AMENDMENTS TO THE DRAWINGS

AMENDMENTS TO THE DRAWINGS

FIGURE 8

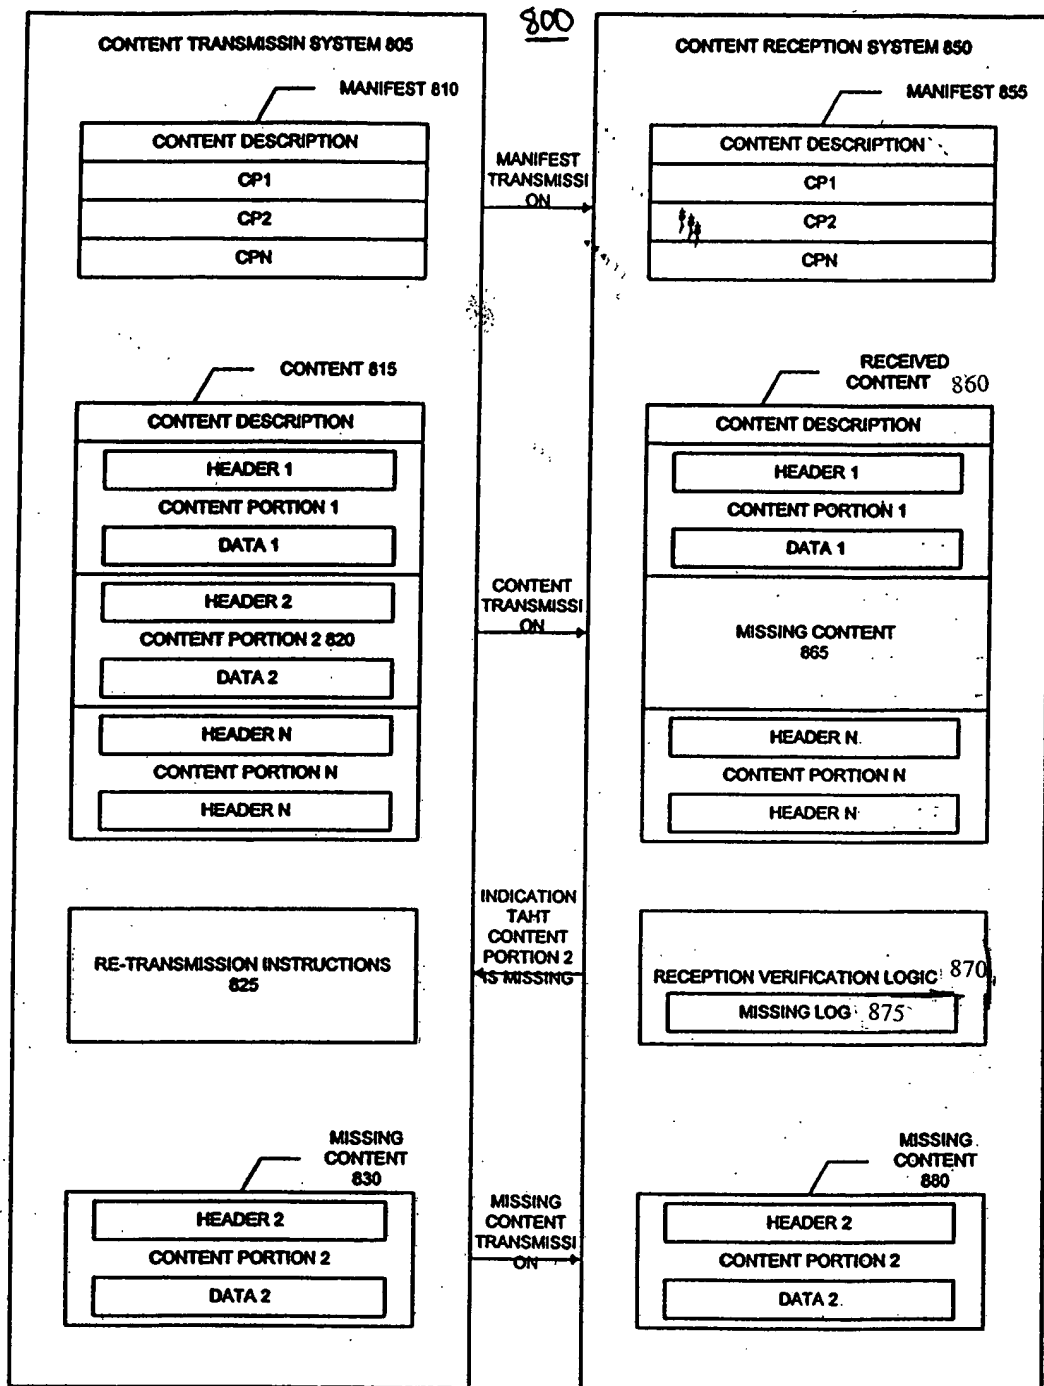
The attached sheets of drawings include changes to Figure 8. These sheets replace the original Figures 8. Figure 8, second column, has been amended as follows:

“RECEIVED CONTENT 815” should be replaced with “RECEIVED CONTENT 860”; and

“RECEPTION VERIFICATION LOGIC 970” should be replaced with “RECEPTION VERIFICATION LOGIC 870”; and

“MISSING LOG 975” should be replaced with “MISSING LOG 875”.
